Conceptual Review Agenda

Monday, February 1, 2016

1303 Plum St Multi-family

CONCEPTUAL REVIEW: APPLICATION

2 nd - 5 th floor

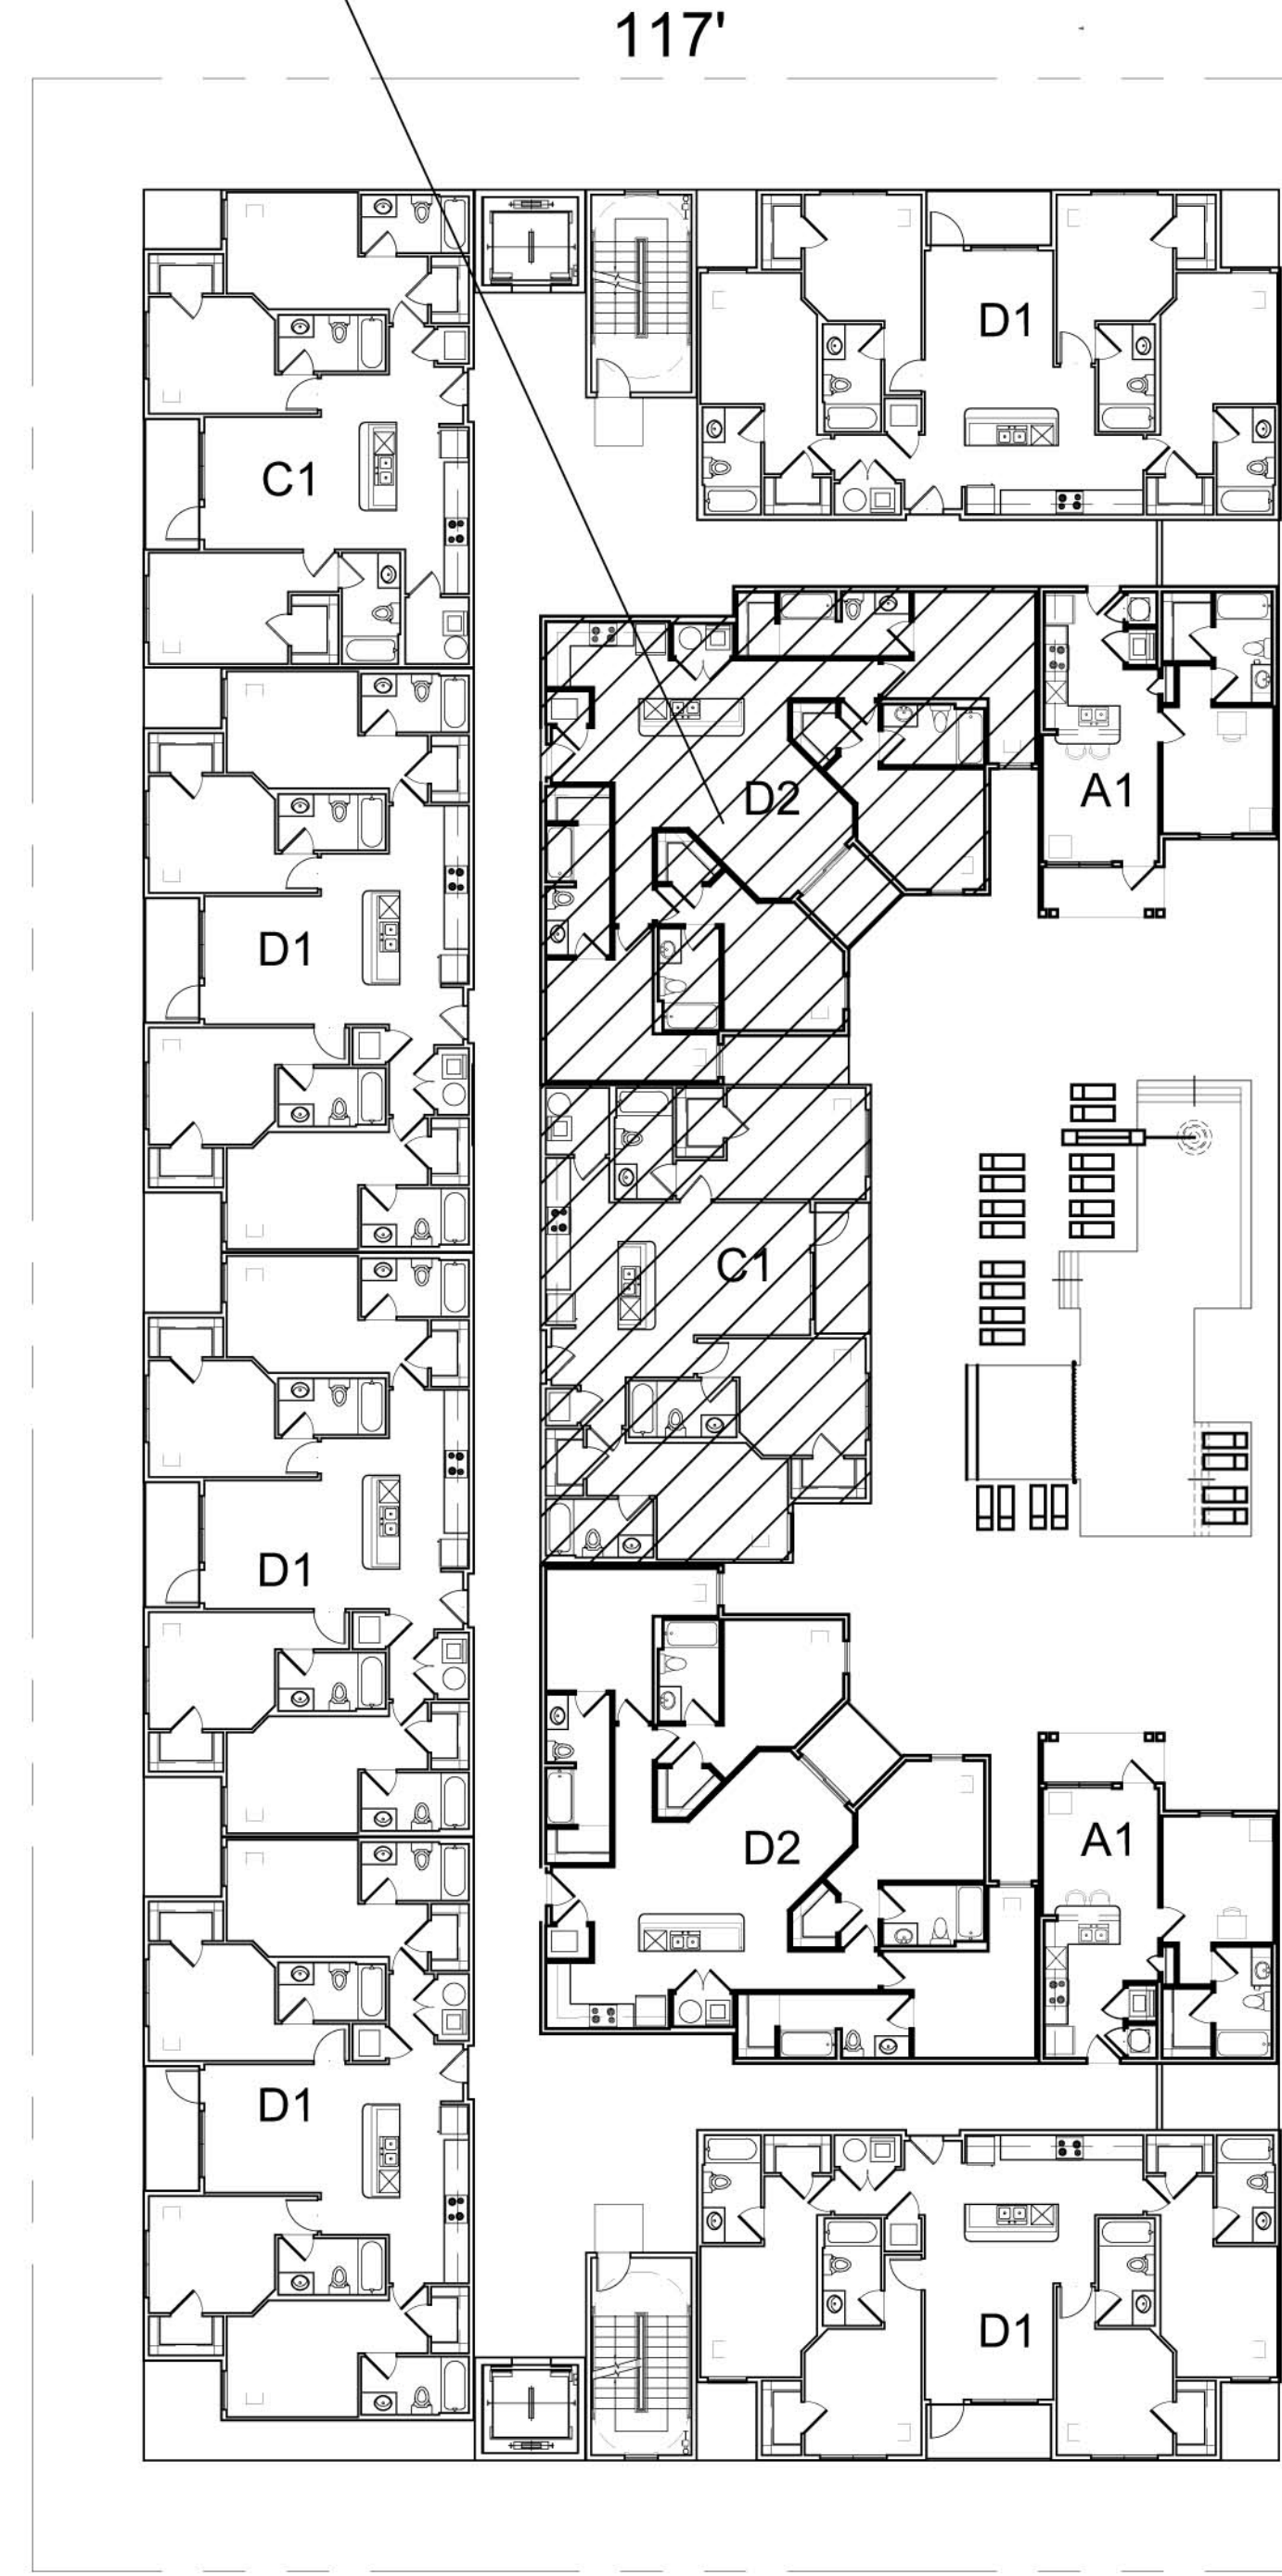
1. If the plan is to rent by bedroom then a minimum 103 off-street parking spaces are required per the TOD parking requirements. If renting per dwelling unit then 56 off-street vehicle spaces are required per TOD requirements. Proposed plan shows 98 off-street parking spaces. Please refer to LUC 3.2.2 for parking regs.

5. The plans need to show mechanical equipment (vents, flues, RTU, meters, electric boxes, conduit) locations and how these are screened
6. A lighting is required. This is a photometric site plan with catalog cut-sheets of the proposed fixtures.

Fire access is required to within 150' of all exterior portions of the building perimeter. Calculating accessibility from Plum Street leaves the building approximately 230' out-of-access. The out-of-access condition can be reduce to approximately 50' if a cross access easement can be established with the property to the east, but that drive aisle will also be required to be dedicated as an EAE and meet minimum fire lane standards and provide a turnaround. See also PFA comment #3 (below) for specific fire lane requirements pertaining to buildings greater than 30' in height. Code language and fire lane specifications provided below.

Buildings exceeding 30' in height are required to meet aerial fire apparatus access requirements as per 2012 IFC Appendix D. In such cases where site limitations do not allow the code to be met, the fire marshal will allow the project team to present a formal plan for meeting the intent of the fire code via means of alternative compliance. Such a plan is required to be presented in writing for review and approval prior to issuance of a building permit. Code language provided below.

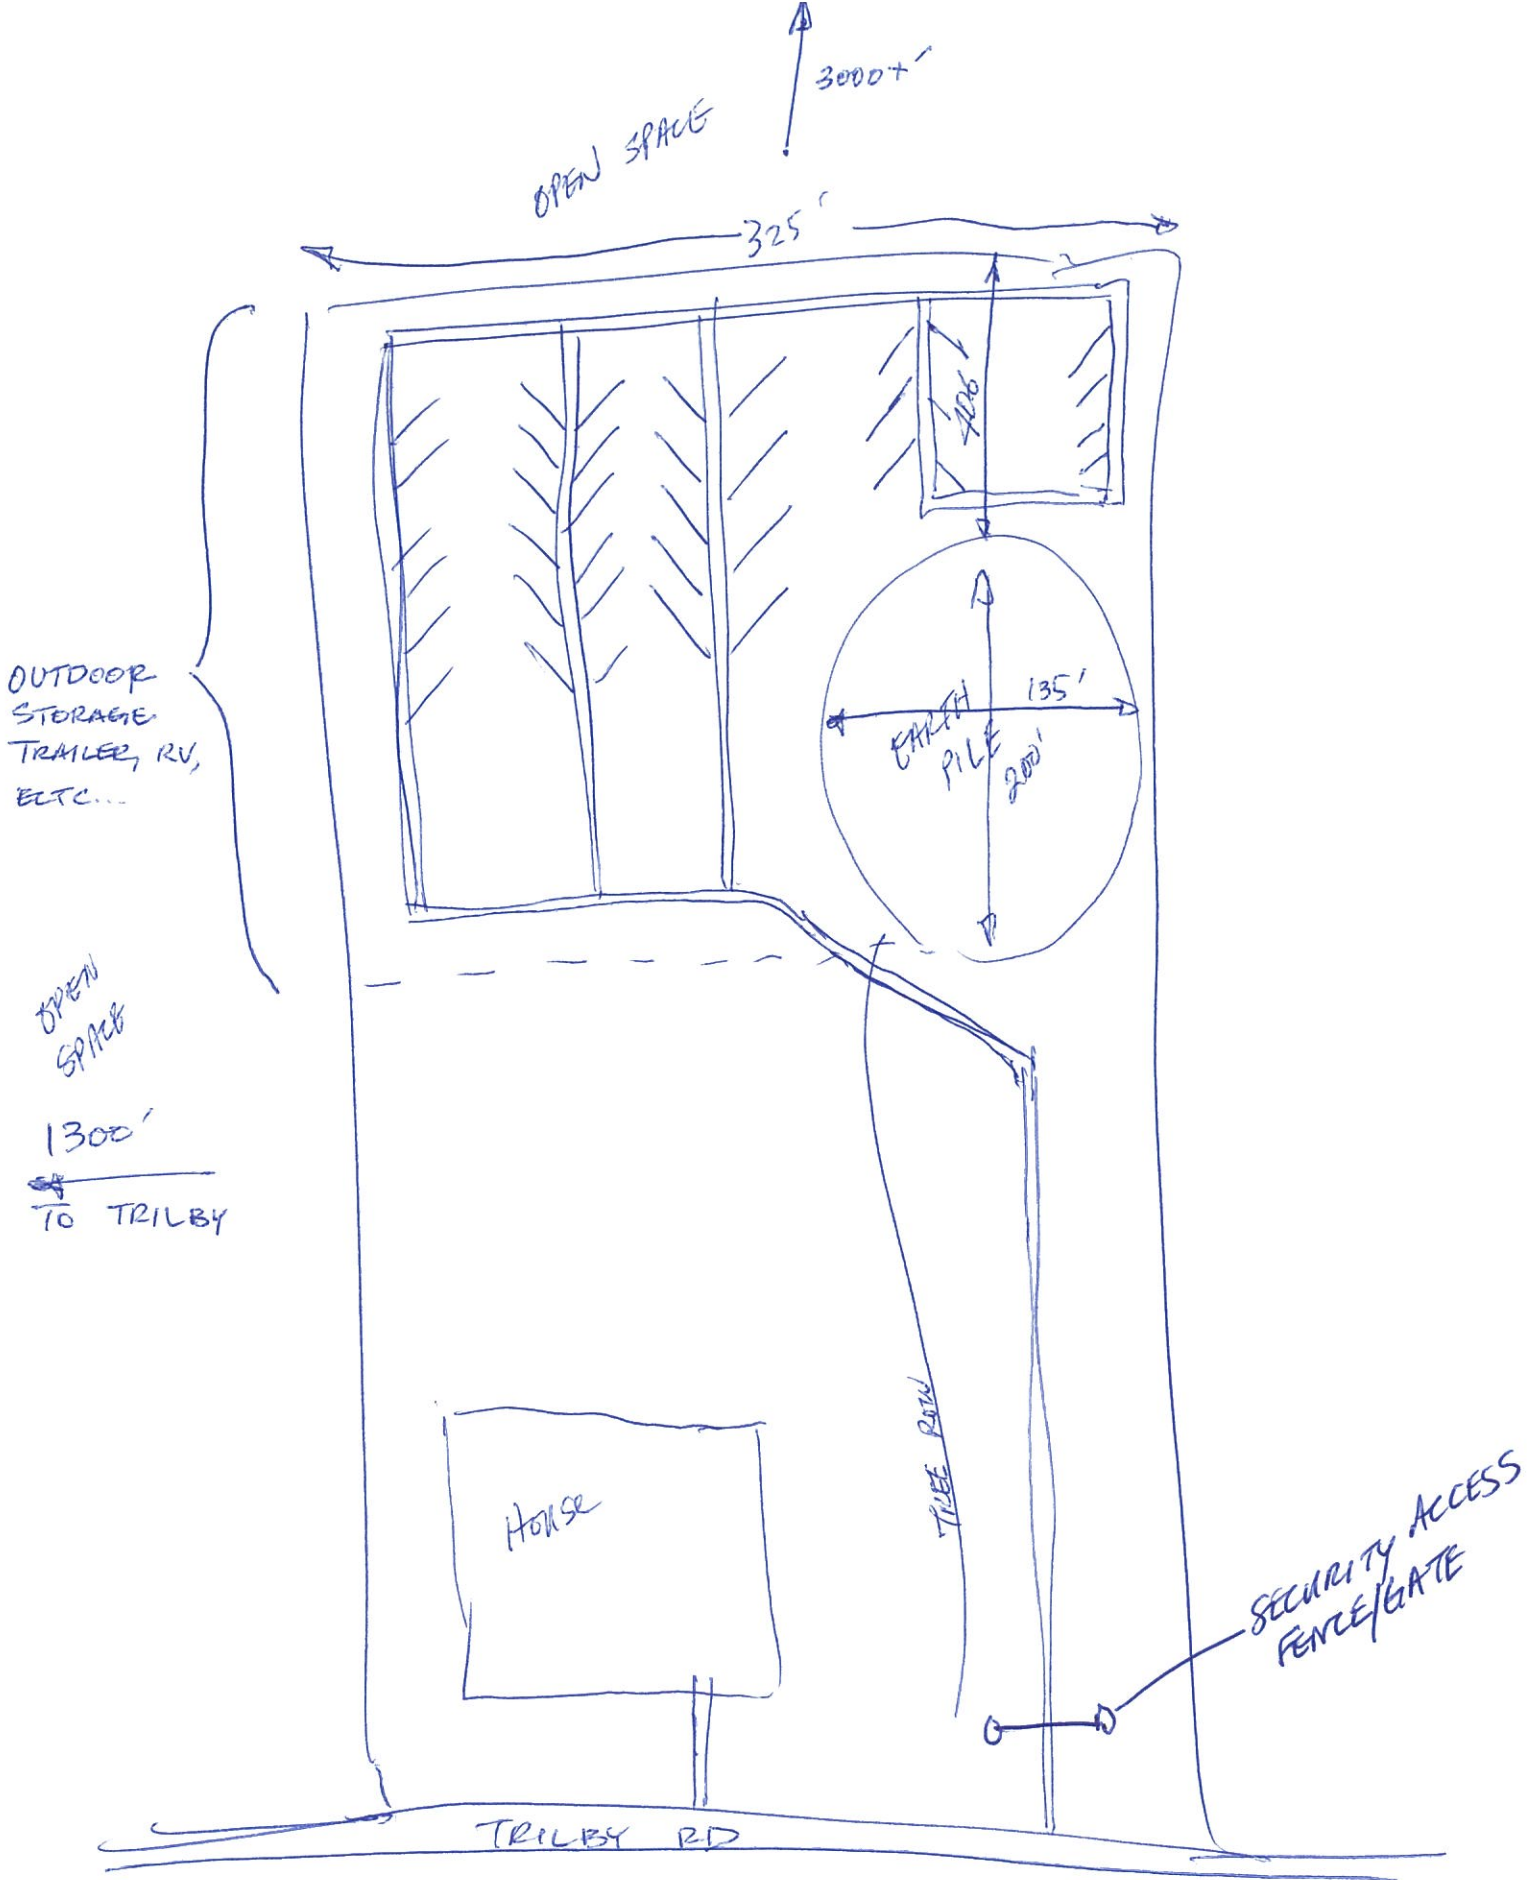
9. The security gate should be set back far enough to provide sufficient space for vehicles towing trailers/boats to get off of the roadway.
10. A traffic study will be required to determine whether or not a left turn lane needs to be installed with this project.

1. Outdoor storage is not an allowed use in the Rural Lands (RUL) zone district.
2. Since outdoor storage is not an allowed use, this project will be subject to the Addition of Permitted Use (APU) process. The APU process requires two neighborhood meetings, a public hearing at the Planning and Zoning Board, and approval by City Council. Staff would not support outdoor storage as a use on this parcel.
